### JURUPA COMMUNITY SERVICES DISTRICT RIVERSIDE. CALIFORNIA

#### **ADDENDUM NO. 5**

# TO THE PLANS AND SPECIFICATIONS FOR RECYCLED WATER PROGRAM – SEGMENT 2 FINAL DESIGN JCSD P.N. C215078

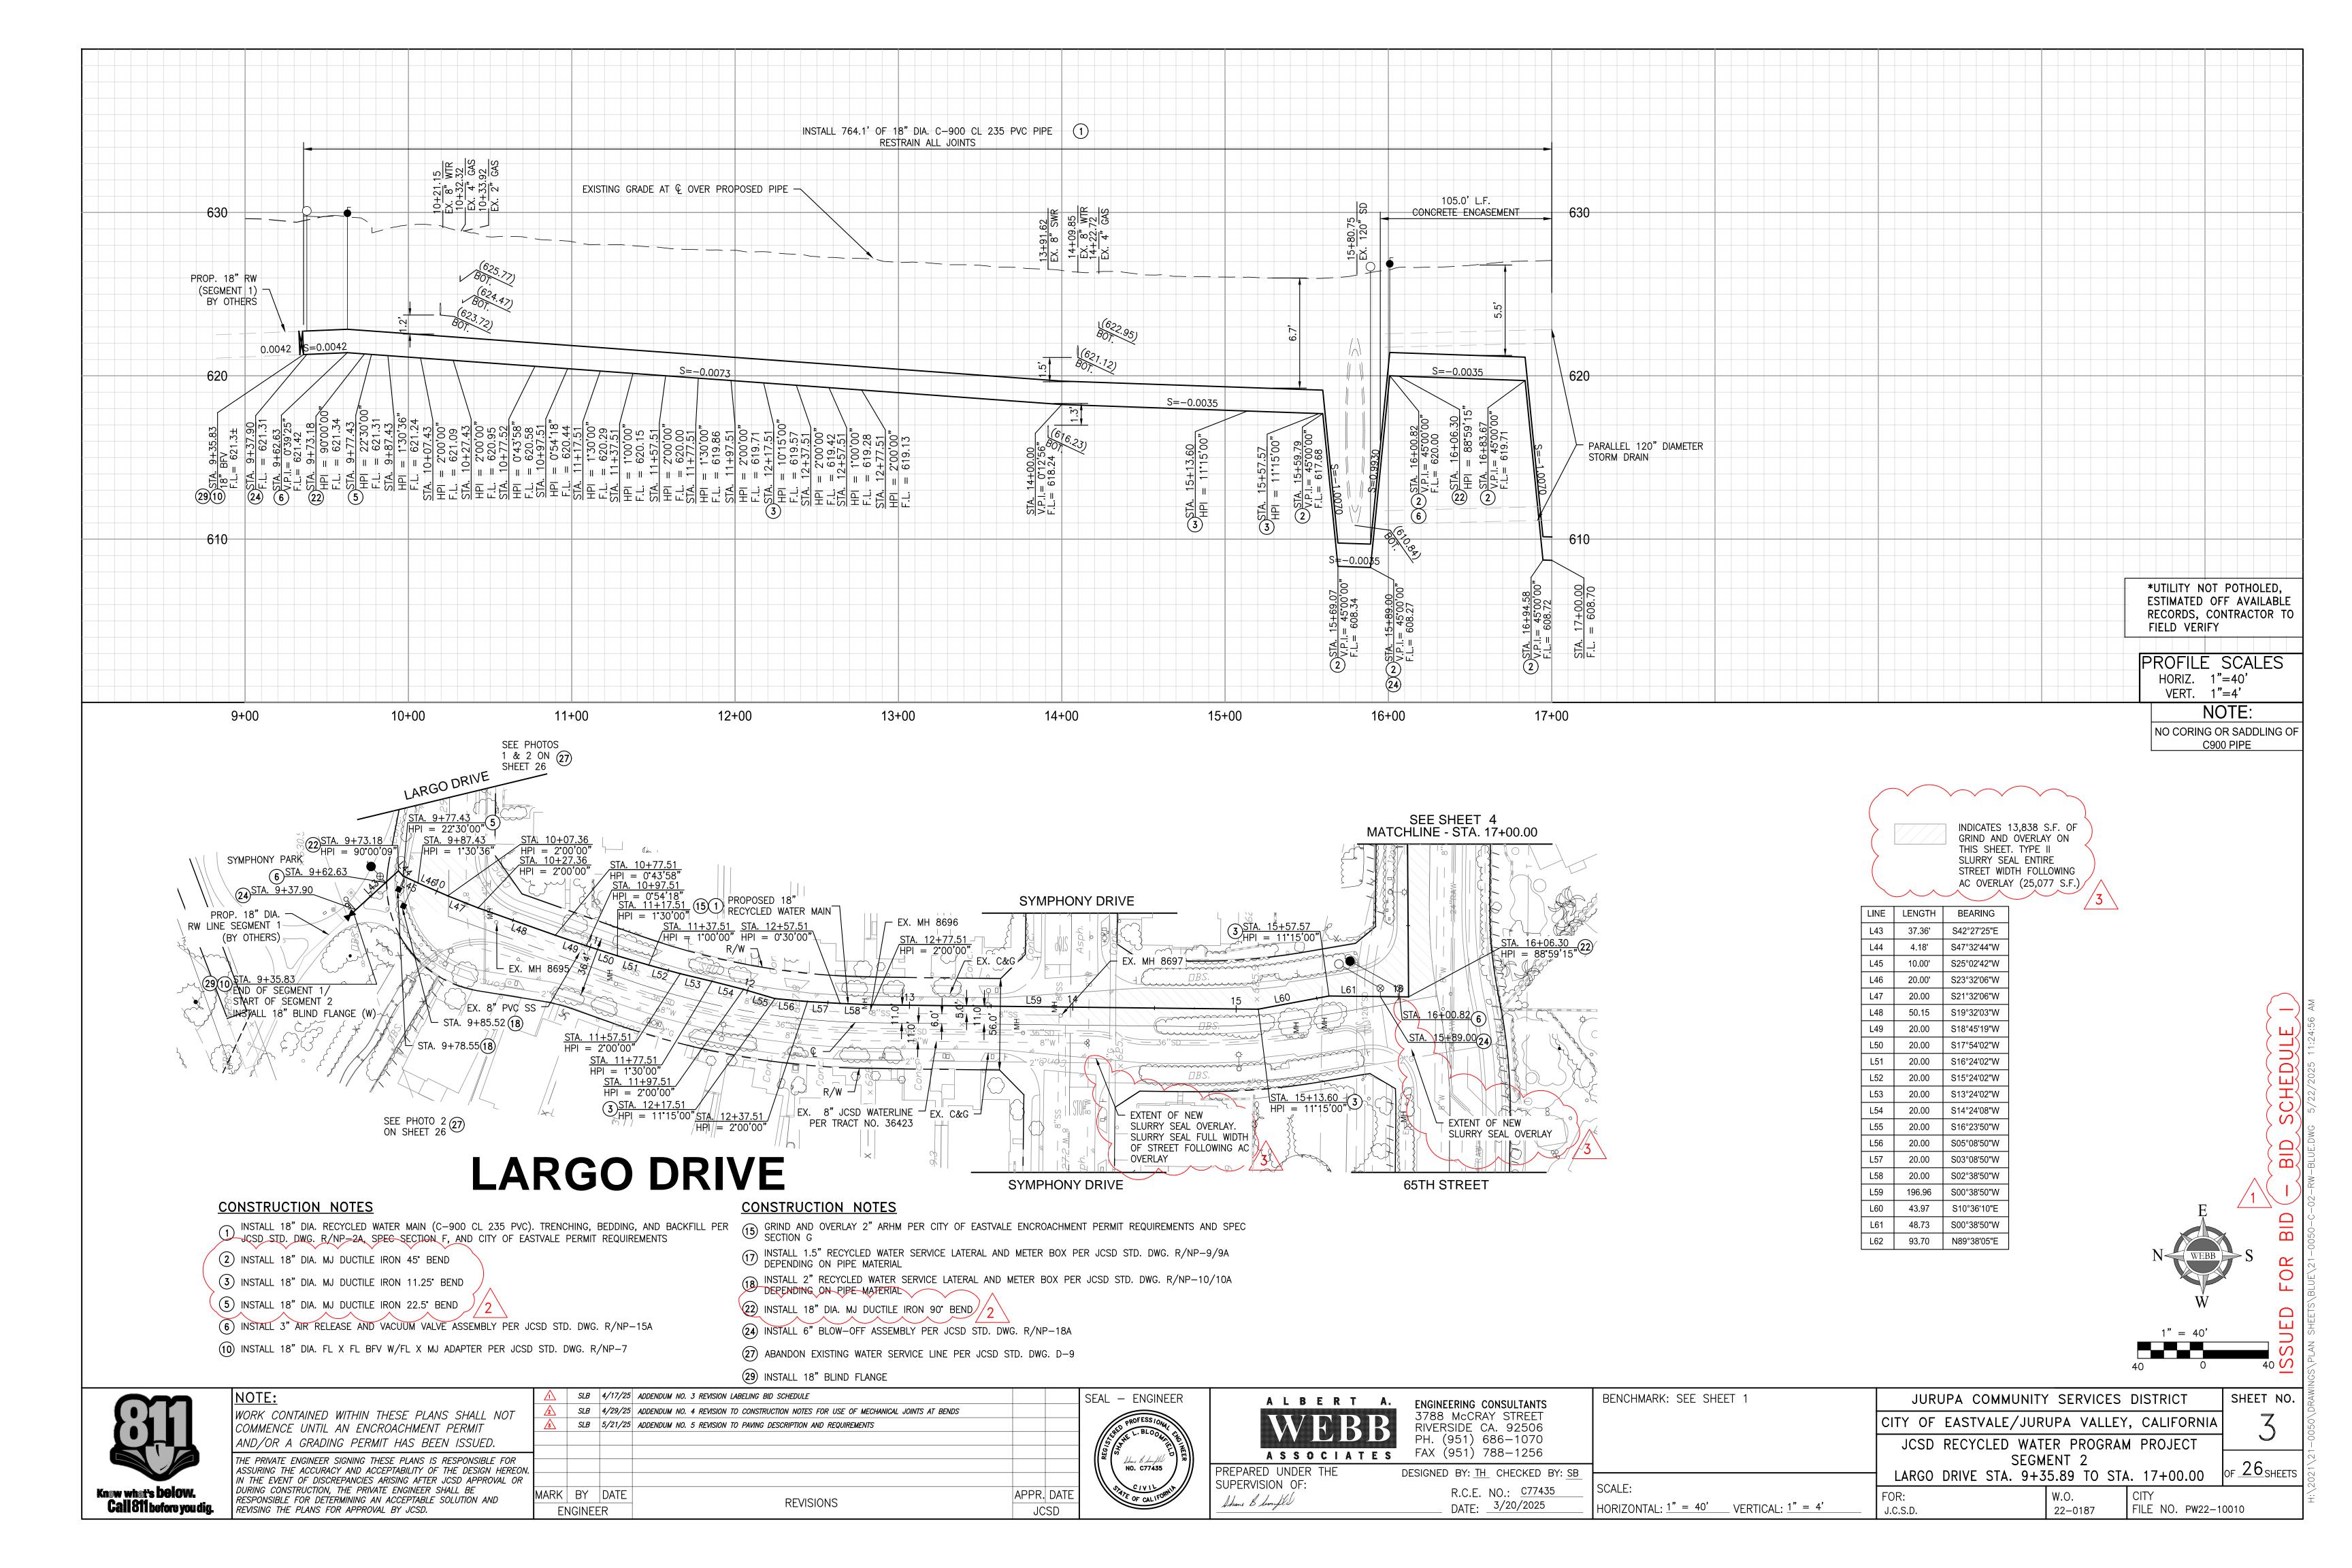
Attached Sheets 3, 15, and 16 (Bid Schedule I) have been revised to indicate the requirement to slurry seal the entire width of road following grind and overlay activities, due to these street's inclusion in the City of Eastvale paving Moratorium List. The limits of the slurry seal have been indicated on the revised Sheets 3, 15, and 16, attached herein.

INDICATES 7,989 S.F. OF GRIND AND OVERLAY ON
THIS SHEET. SLURRY SEAL
ENTIRE STREET WIDTH
FOLLOWING AC OVERLAY (17,362 S.F.)
